# Report of the Cheekye River (Ch'kay Stakw) and Fan Expert Review Panel

Prepared by the Panel Members:

April 23, 2014

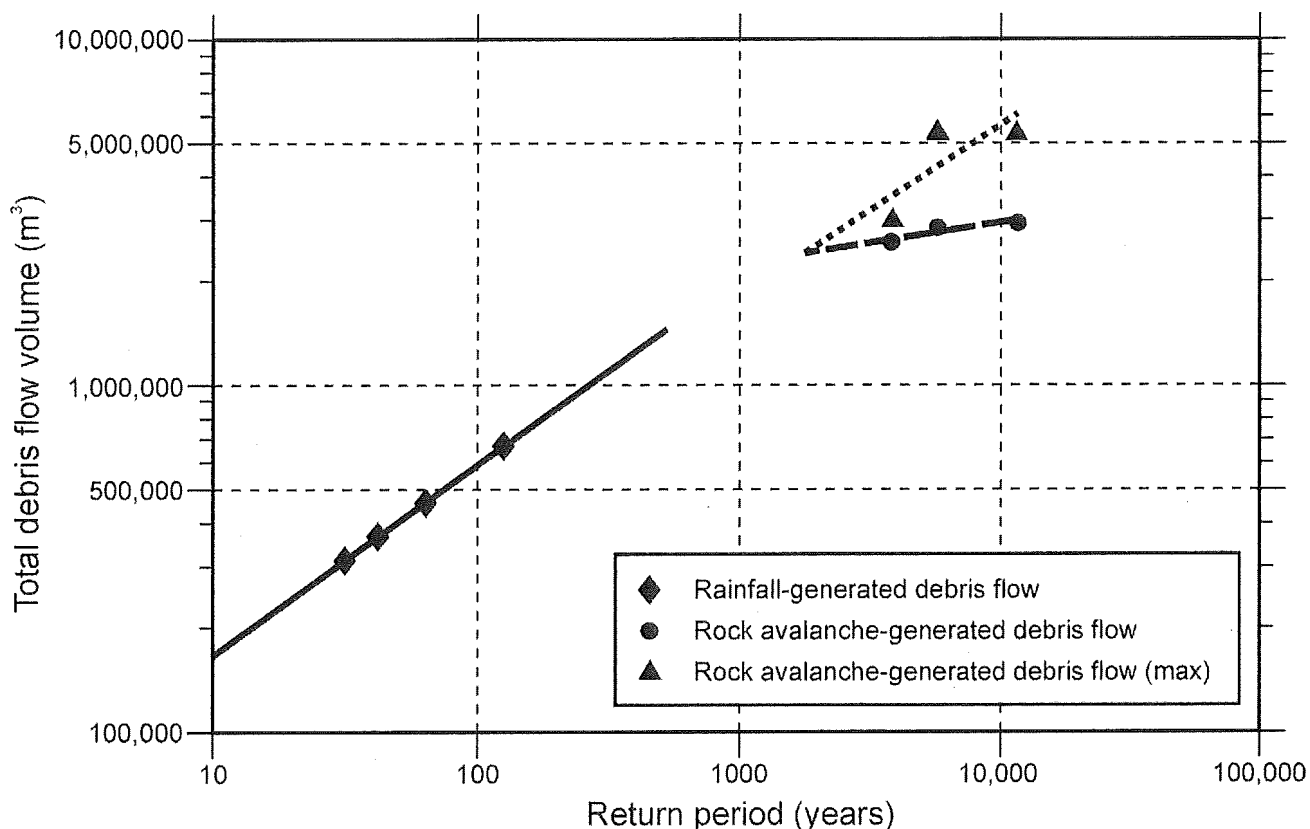
As mentioned in Section 3.2 of this report, it is the Panel's opinion that BGC's MCF relationships (redrawn as Figure 3 in this report) are the most reliable MCF relationships currently available for Cheekye Fan. The Panel agrees with BGC's interpretation and division of observed debris flows into two populations as shown on Figure 3.

It is the Panel's opinion that the solid line on the left side of Figure 3, representing smaller volume rainfall/surface water runoff-generated debris flows, is credible and could be a basis for considering debris flow mitigation strategies for this range of smaller volume events. A spectrum of still smaller events, such as debris floods or stream floods, not shown on Figure 3, should also be considered in mitigation strategies.

The lines on the right side of Figure 3, which represent rock slide-generated debris flows that could potentially transport more than 2 million m<sup>3</sup> of debris to the Cheekye Fan, are discussed in Section 4 of this report.

The right side of BGC's MCF relationships (the dashed and dotted lines on Figure 3 in this report) is based on three debris flows. Only the smallest of these events was estimated with some reliability, as described in BGC (2008a). The deposits of the remaining two debris flows are buried deep in Cheekye Fan and their volumes could only be estimated with wide error margins. As estimated by BGC (2008a), the volume of either one of these debris flows could have been as large as 5.4 million m<sup>3</sup>.

It is the Panel's opinion that the upper (dotted) line on right side of BGC's MCF relationships (drawn as Figure 3 in this report) provides a prudent estimate of the volume of debris that could be transported to Cheekye Fan during a rock slide-generated debris flow. Therefore, it is the Panel's opinion that the volume of the 10,000-year debris flow that could reach Cheekye Fan is 5.5 million  $\text{m}^3$ . This estimate is more conservative than was recommended by

It is the Panel's opinion that climate change might increase the frequency of smaller rainfall/water runoff-generated debris flows and debris floods, consistent with the conclusion of BGC (2008a). This expectation would shift the solid line on the left side of Figure 3 of this report to the left, although the amount of the shift is unknown. This shift would have the effect of increasing the volumes of given-year events.

It is the Panel's opinion that climate change might also increase the frequency of major rock slide-generated debris flows, which would also shift the dashed and dotted lines on the right side on Figure 3 of this report to the left. It is expected that the shift for major rock slide-generated debris flows will be less than for rainfall/surface water runoff-generated debris flows and debris floods, although this inference is by no means certain. This shift would have the effect of increasing the volume of the 10,000-year event.

Figure 4: Comparative profiles of Capricorn Creek below Mount Meager (drawn along the runout path of the August 2010 landslide) and the Cheekye River below Mount Garibaldi (from Google Earth; 2x vertical exaggeration).

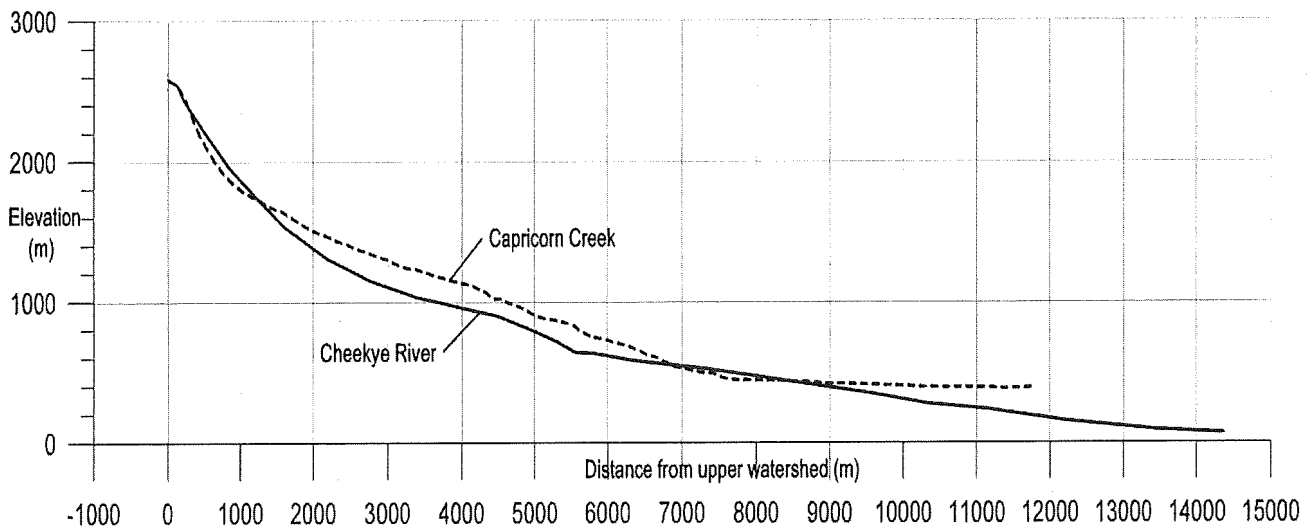
The occurrence of the 2010 Mount Meager landslide suggests that the very steep Cheekye River headwaters could experience a similar event, larger than anything that has happened in the past. Geologically, the conditions of Mount Meager and Mount Garibaldi are similar. The volcanic rocks that are the source of the 2010 Mount Meager landslide (Read, 1977) are similar to those at the head of Cheekye River below Atwell Peak (Mathews, 1958). The former rocks are older (Plio-Pleistocene) than the latter rocks (late Pleistocene), but both are highly broken, weathered, and unstable. The Capricorn Creek and Cheekye River profiles are similar (Figure 4), and similar potential causal and trigger mechanisms exist, such as extreme

precipitation events, glacier retreat, and earthquakes. One significant unknown is the amount of water contained within the rock mass below Atwell Peak.
